# ITT ENGINEERED VALVES

2<sup>nd</sup> Interim Report to the NRC of  
10 CFR 21 Event 50285, reported by ITT 07/18/14  
Concerning M1 diaphragms, Customer Testing

## 1" M1 EPDM Operating Conditions – New Compound

#### 1 in. M1 Operating Curve

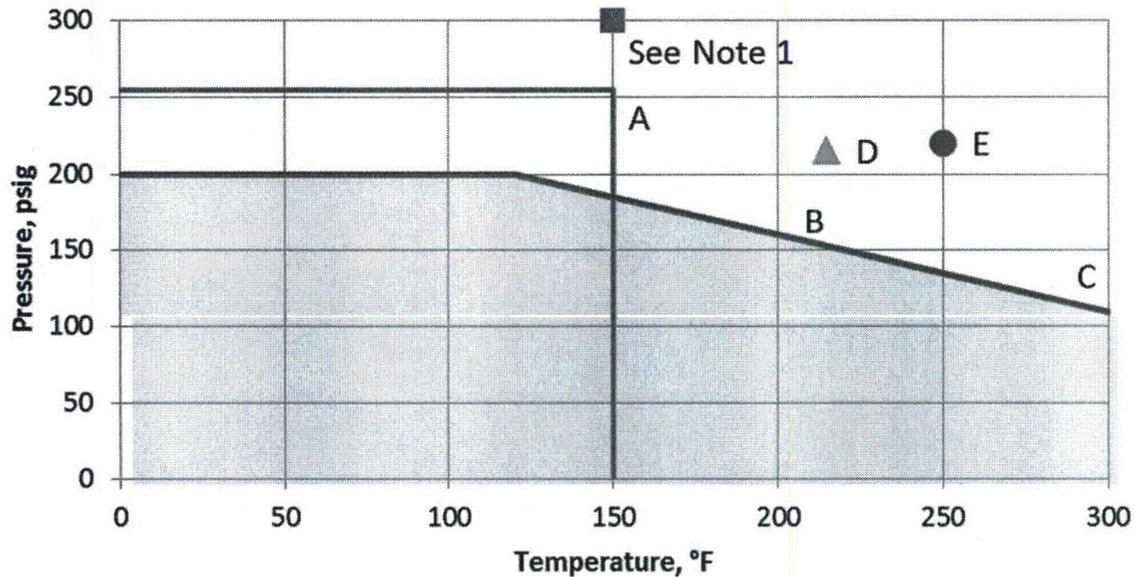
Condition A                      150° F, 255 psig                      (same as shown on 07/31/08 letter)

Condition B, C                    200° F, 160 psig    and    300° F, 110 psig                    (Commercial P/T curve)

Condition D                    215° F, 215 psig    (qualifies both 200° F at 215 psi, and 215° F at 200 psig conditions)

Condition E                    250° F, 220 psig

New 1" M1 fully qualified to 7,500 cycles

New 1" M1 fully qualified to 7,500 cycles for both conditions above

New 1" M1 fully qualified to 7,500 cycles, and exceeded performance of 44673 at this condition.

Was not able to fully qualify new 1" M1 to 7,500 cycles  
 However, exceeded performance of old 1" M1 p/n 44673 at this condition.  
 Did qualify to 4,065 cycles, which translates to  
     Yearly service life of 271 cycles/year, with SF=3, five year service life  
     OR  
     Total service life of 1,355 cycles (4,065 with applied safety factor of 3)

The new 1" M1 p/n 47961 has been successfully qualified as equivalent or better than the previous 1" M1 p/n 44673 for all of the conditions covered on the 7/31/08 Operating Conditions letter (except for the MSS SP-100 test, which has not yet been completed). In addition, the new 1" M1 has proven to be equivalent or better for all customer operating conditions that were not originally part of the 7/31/08 letter but are now included here (conditions B through E above).
